*Proposed McGuire 1 & 2 Tech Specs*

NUREG-0452  
Revision 4

# **Standard Technical Specifications for Westinghouse Pressurized Water Reactors**

FIGURE 2.1-1  
REACTOR CORE SAFETY LIMIT - FOUR LOOPS IN OPERATION

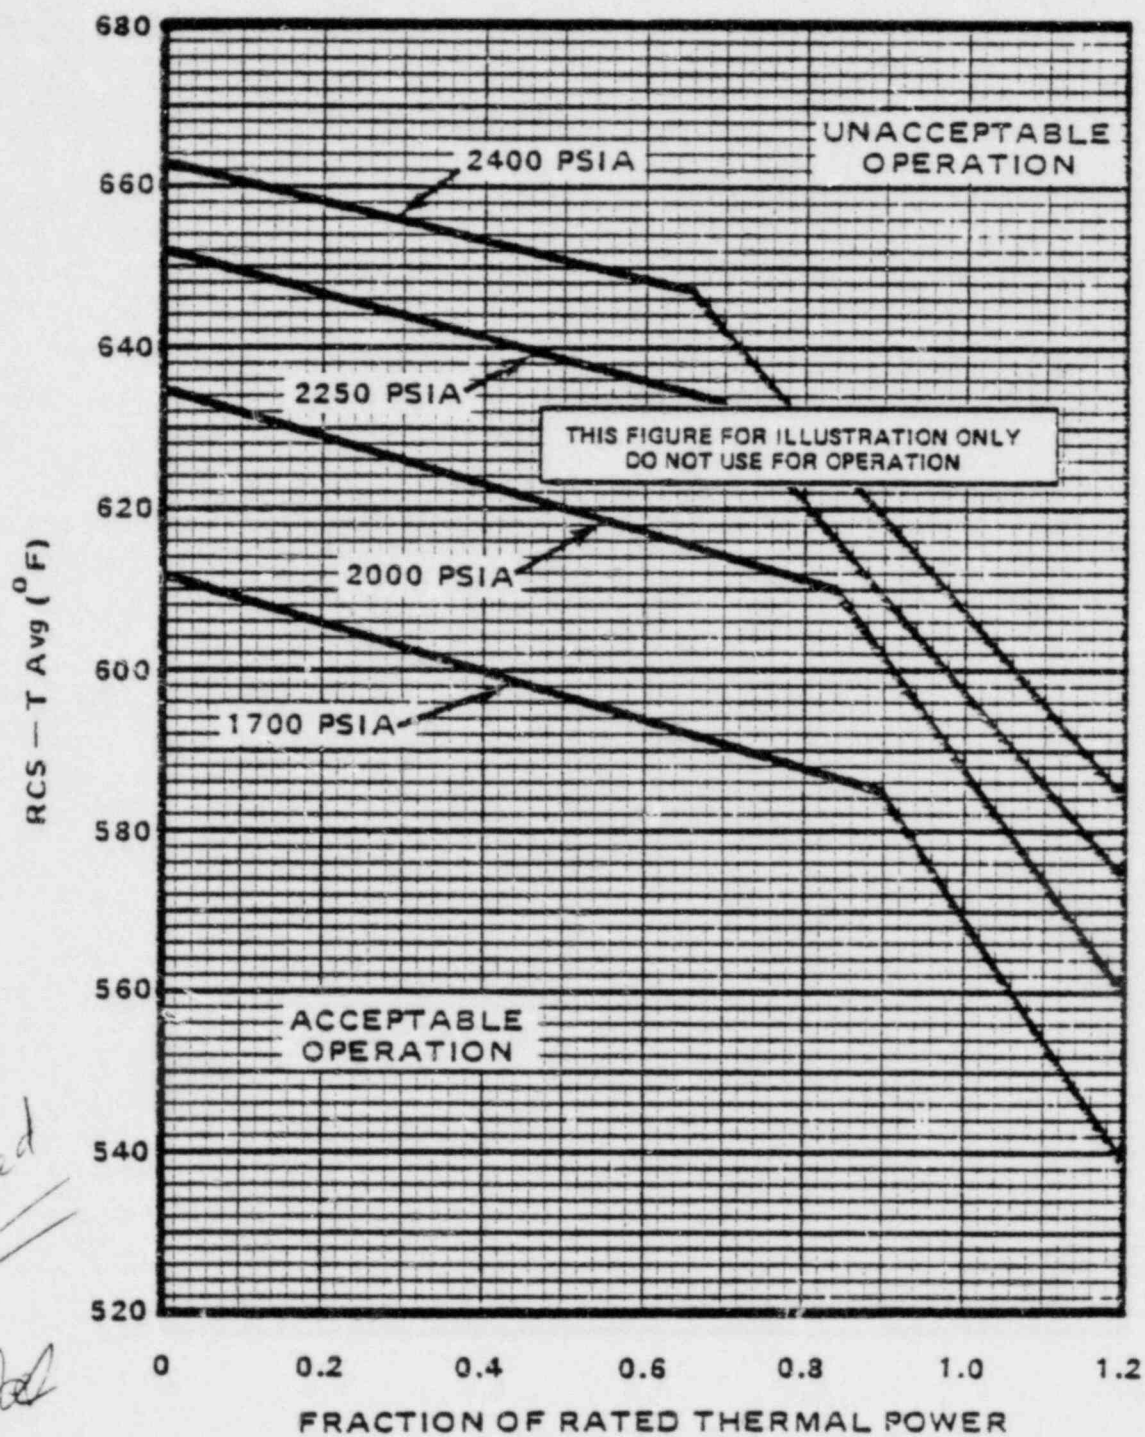
Figure 2.1-2 left blank pending the NRC approval  
of three loop operation

FIGURE 2.1-2

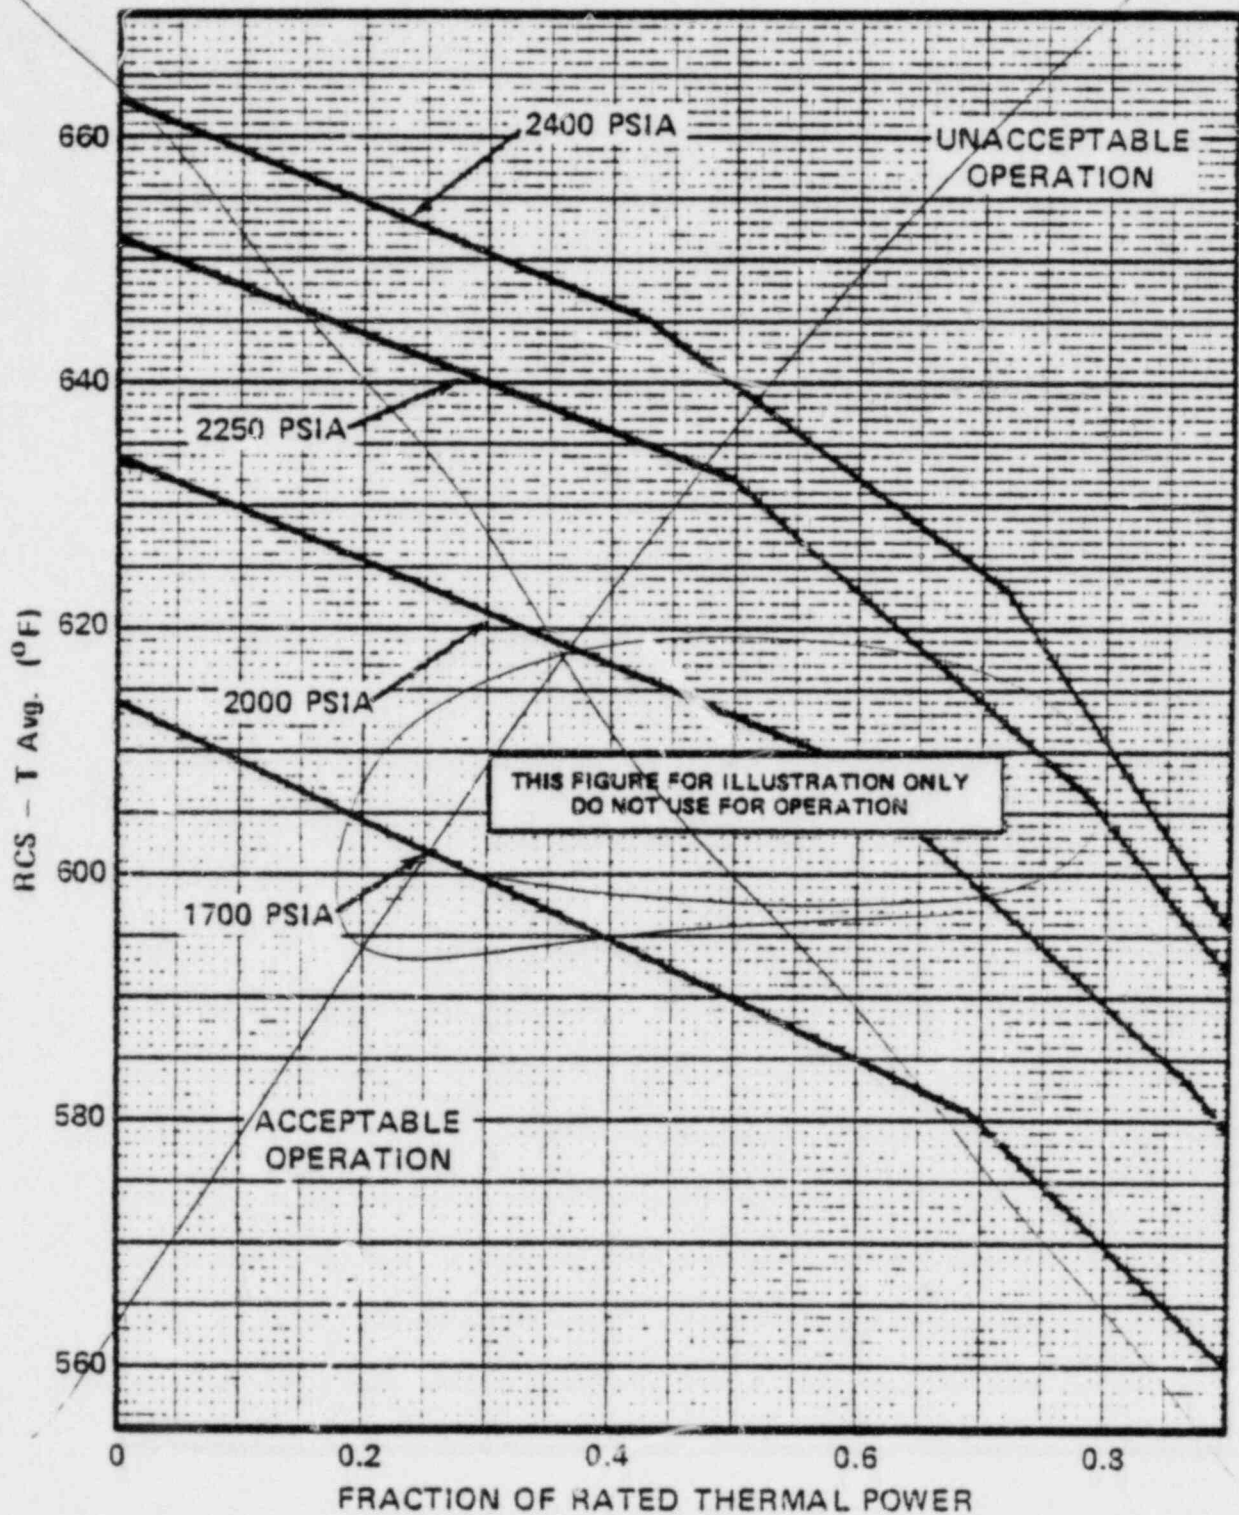
~~Delete~~ Superseded by previous page.

Figure 3.1-2 ROD GROUP INSERTION LIMITS VERSUS THERMAL POWER FOUR LOOP OPERATION

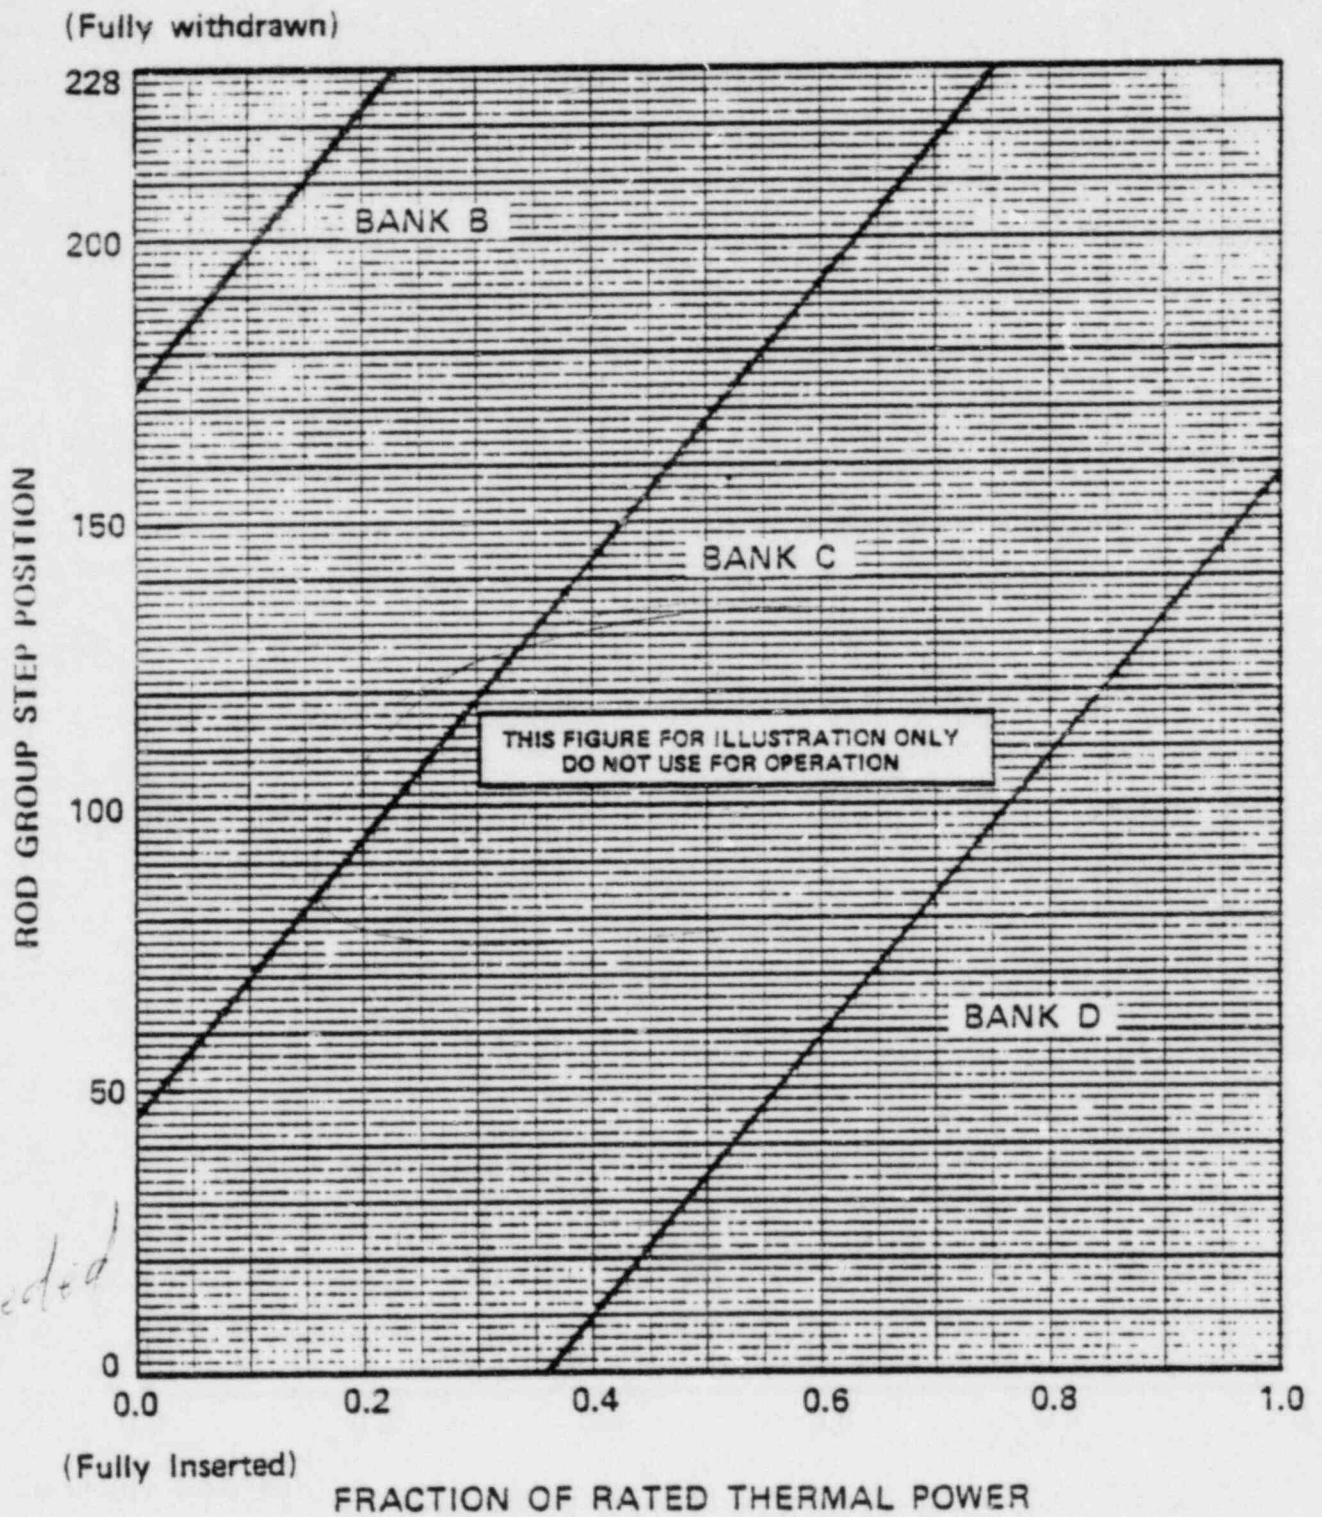
Delete

FIGURE 3.2.2.  
 $K(Z) - F_Q(Z)$  AS A FUNCTION OF CORE HEIGHT

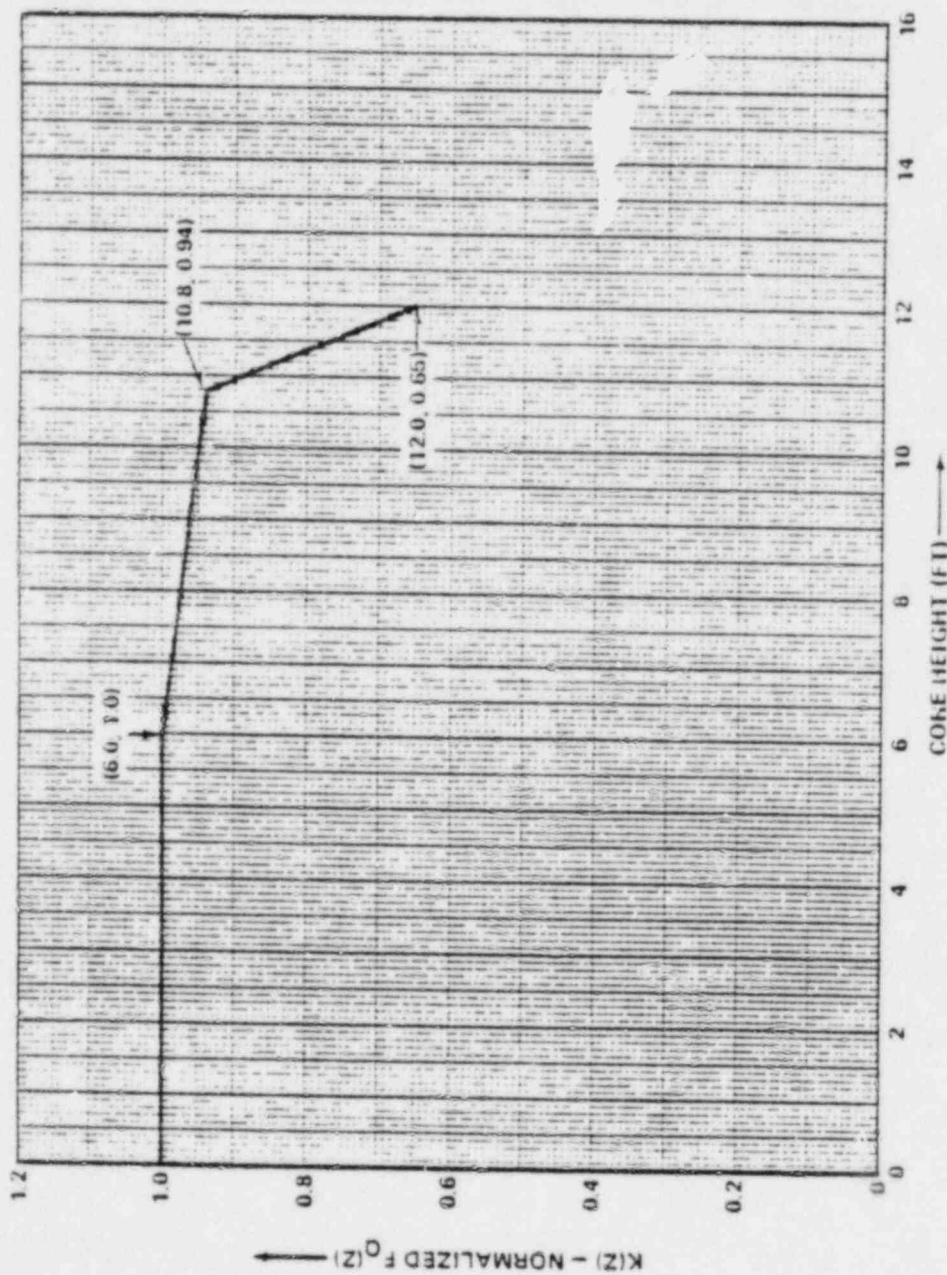
*Superseded*

FIGURE 3.2-2  $K(Z) - \text{NORMALIZED } F_0(Z)$  AS A FUNCTION OF CORE HEIGHT

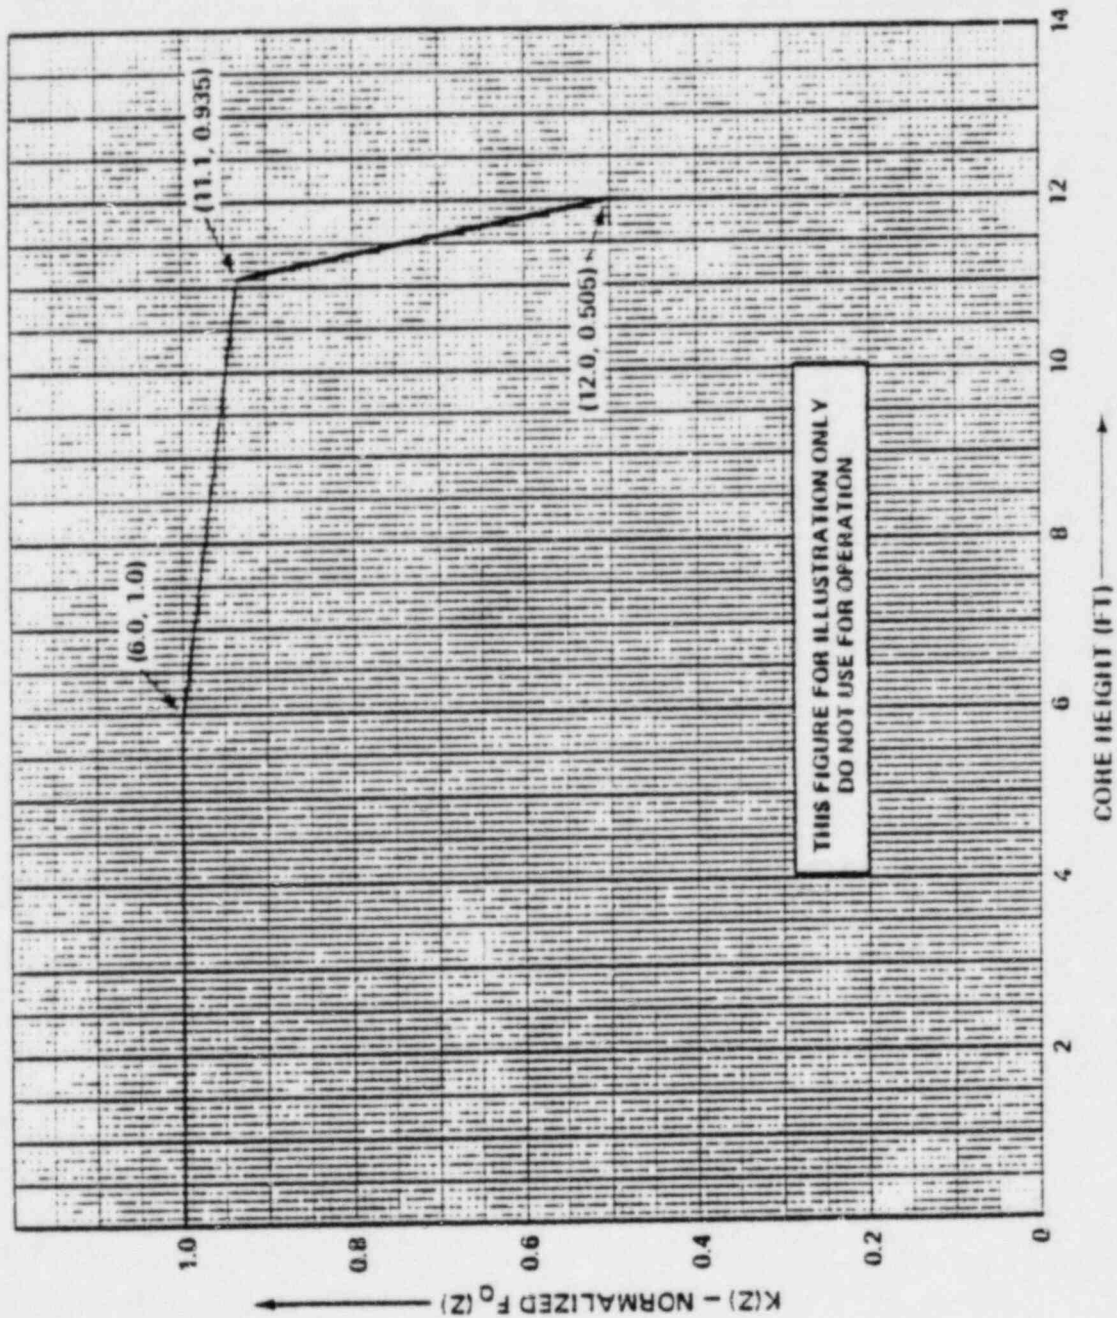
*Superseded*

Figure 3.4-3 Reactor Coolant System Pressure - Temperature Limits Versus Cooldown Rates

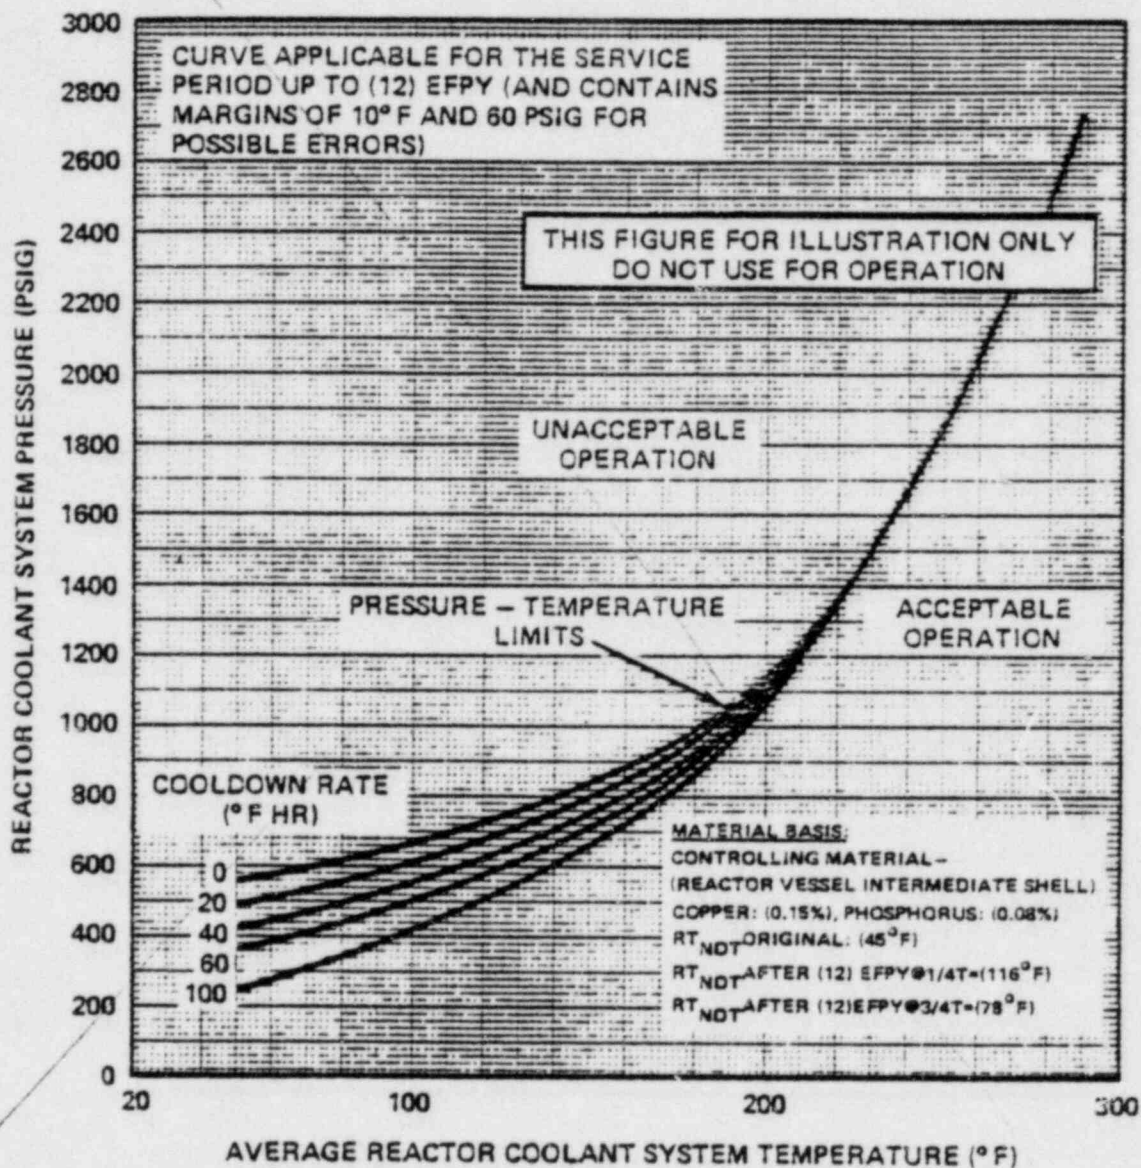
superseded
